ERRATA SHEET

Report Number: NUREG/CR-4731, Vol. 2

Report Title: Residual Life Assessment of Major Light  
Water Reactor Components--Overview

Prepared by: EG&G Idaho, Inc.

Figure 5.3. Typical Combustion Engineering safety injection system (simplified).

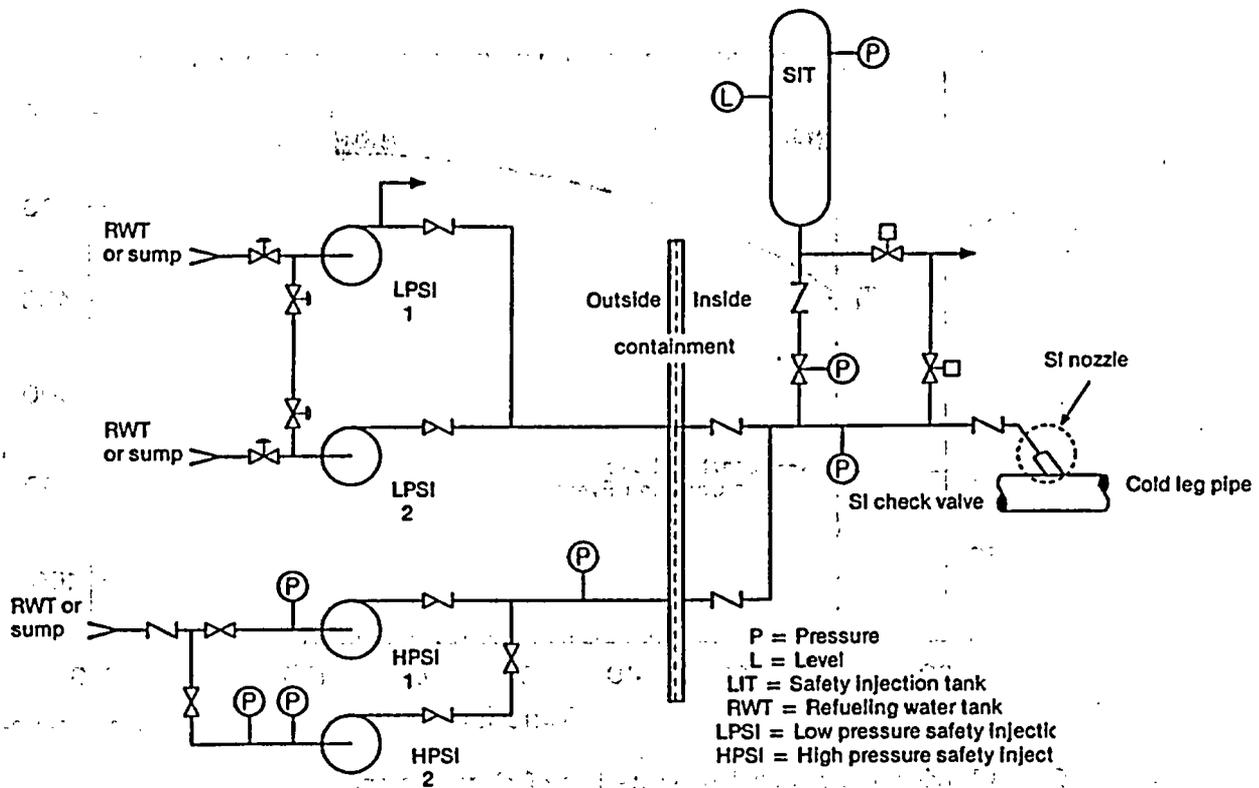
Page 65, Figure 5.3 Legend

LIT = Safety injection tank, change to read:

SIT = Safety injection tank

Figure 10.9. General Electric fatigue data plotted in accordance with modified ASME Code design curves for carbon steel.

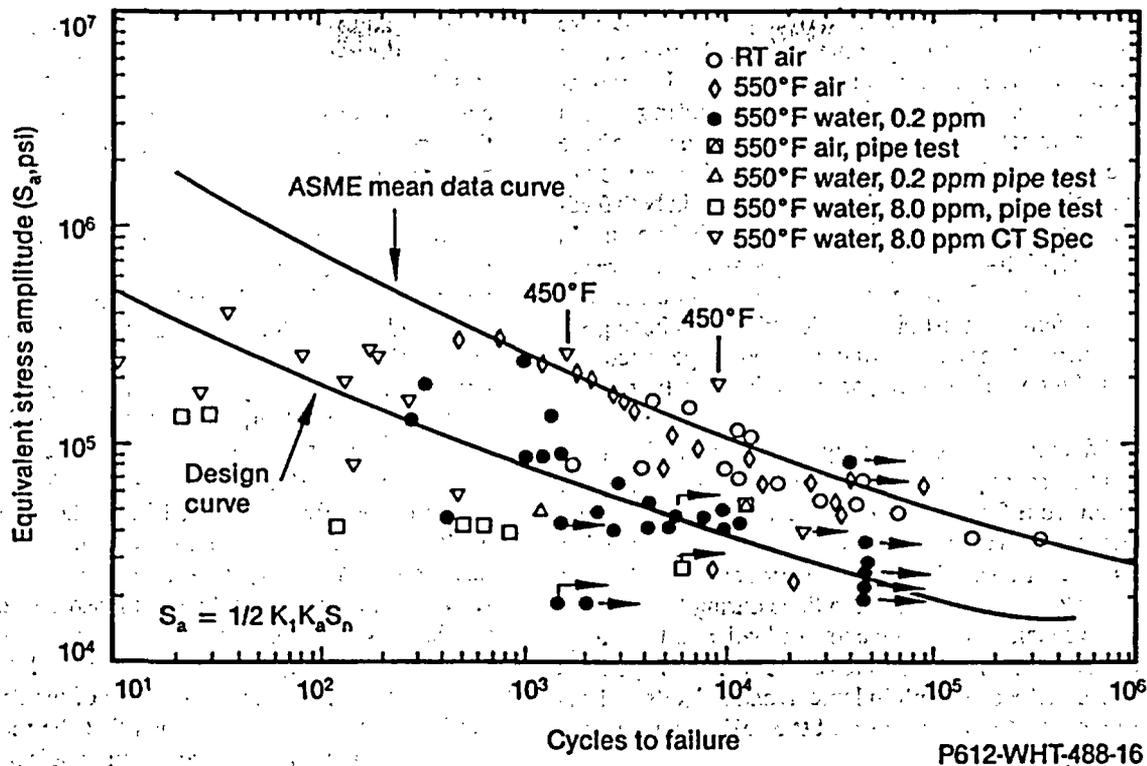
Page 221, Figure 10.9, pseudo-stress amplitude equation

$S_a = 1/2 K_1 K_a S_n$ , change to read:

$S_a = 1/2 K_t K_e S_n$
